Ref. No. 201505011
Petition No. 639

- (X) Involved; have no objection to the requested encroachment into E. Baltimore at 207 E. Baltimore (with canopy, wall sconces & uplighting) as shown on drawing no. x639 dated 5/11/2015 provided that the following conditions are met with:

REQUEST ENCROACHMENT
 INTO E. BALTIMORE
 AT 207 E. BALTIMORE
 (With Canopy, Wall Sconces & Uplighting)

CITY OF DETROIT	
CITY ENGINEERING DEPARTMENT	
SURVEY BUREAU	
JOB NO.	01-01
DRWG. NO.	X 639

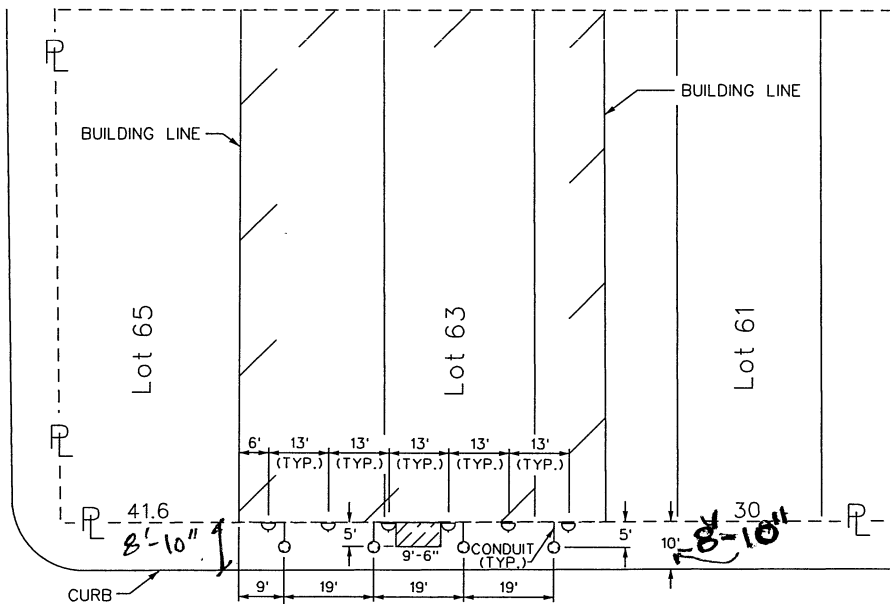
- 1) The in-ground lighting shall be finished flush with the sidewalk and the sidewalk shall be made ADA compliant after installation of the in-ground uplighting.

- 2) The canopy shall be cantilevered and shall provide a minimum vertical clearance of 12 ft height between the existing sidewalk and the bottom of the proposed canopy.

- 3) The wall sconces shall provide a minimum vertical clearance of 12 ft between the existing sidewalk and the bottom of the sconce.
